TECHNICAL MEMORANDUM

TO: Emma Porricolo and Don Hardy, City of Canby

FROM: Kevin Chewuk and Eileen Chai | DKS Associates

SUBJECT: Canby Manzanita Street Apartments
Transportation Analysis Letter

FIGURE 1: SITE PLAN

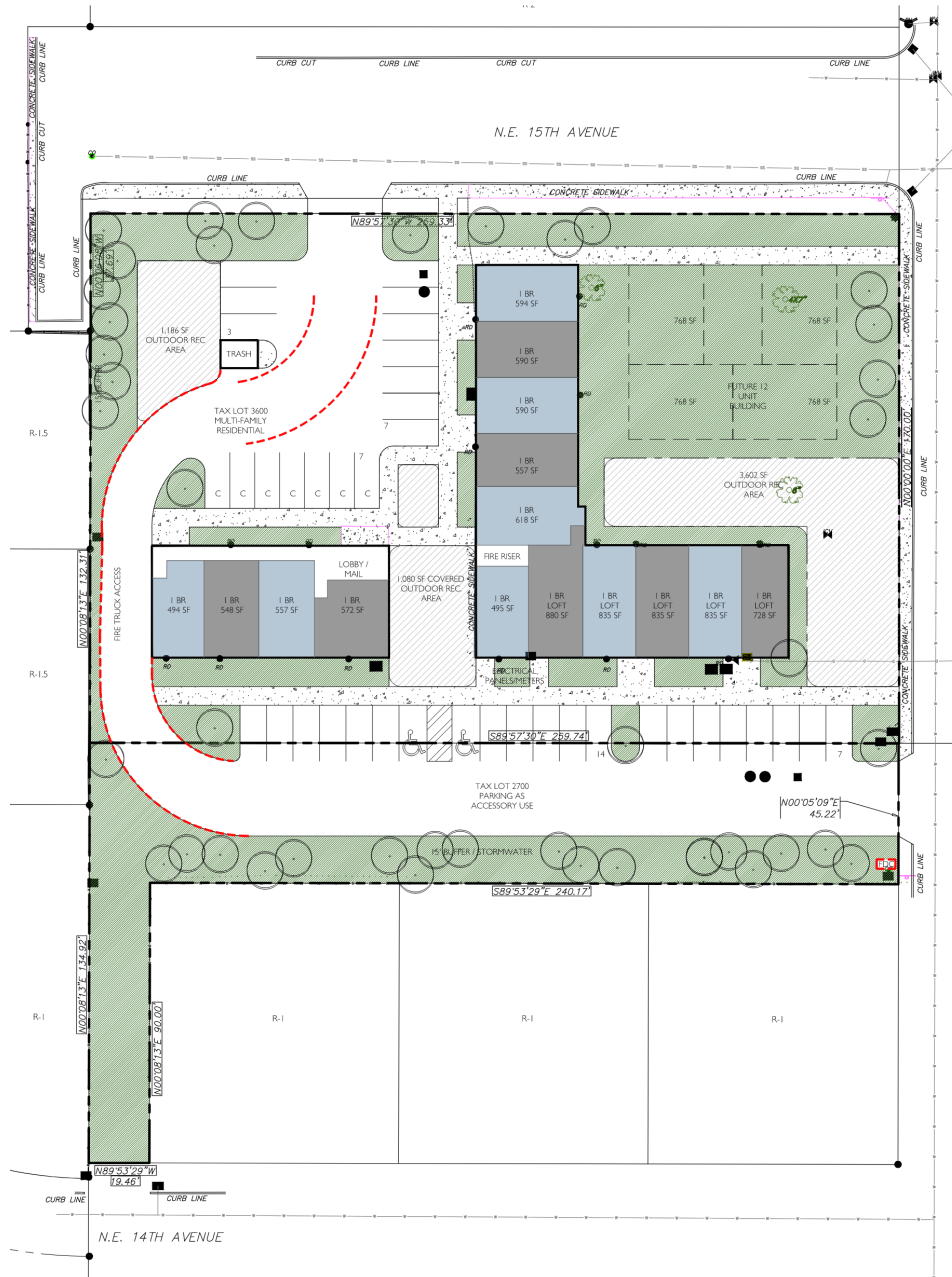
City standards require that accesses along a Local Street must be a minimum of 10 feet between driveways and 50 feet between roadway to driveway along the same side of the street¹. The two existing site driveways to NE 15th Avenue are proposed to be consolidated into a single driveway to be located approximately 200 feet from N Manzanita Street, complying with the spacing standard. The existing driveway on N Manzanita Street will be maintained and will be approximately 180 feet from NE 15th Avenue to the north and approximately 120 feet from NE 14th Avenue to the south, also complying with the spacing standard.

The proposed driveways would require a minimum of 225 feet of sight distance based on a 20 mile per hour design speed. Preliminary sight distance evaluation from the driveway on NE 15th Avenue indicates that the connection would be expected to provide sight distance to N Manzanita Street looking to the east. Preliminary sight distance evaluation from the driveway on N Manzanita Street indicates that the connection would be expected to provide sight distance of over 600 feet looking to the north and south.

The proposed site plan (shown earlier in Figure 1) shows two driveways connecting to NE 15th Avenue and N Manzanita Street. The proposed driveways will be full access, allowing for ingress/egress to the on-site parking areas for vehicles and bicycles and will provide adequate circulation to the surrounding existing roadway network and internally within the site.

The site plan also includes proposed sidewalks from NE 15th Avenue and N Manzanita Street connecting to the building entrances and parking areas.

1. The development shall design and reconstruct the existing sidewalk along the NE 15th Avenue frontage with a 6-foot sidewalk.
2. The development shall design and reconstruct the existing sidewalk along the N Manzanita Street frontage with a 6-foot sidewalk.
3. Minimum sight distance requirements shall be met at all site accesses. Sight distances should be verified in the final engineering/construction stages of development.
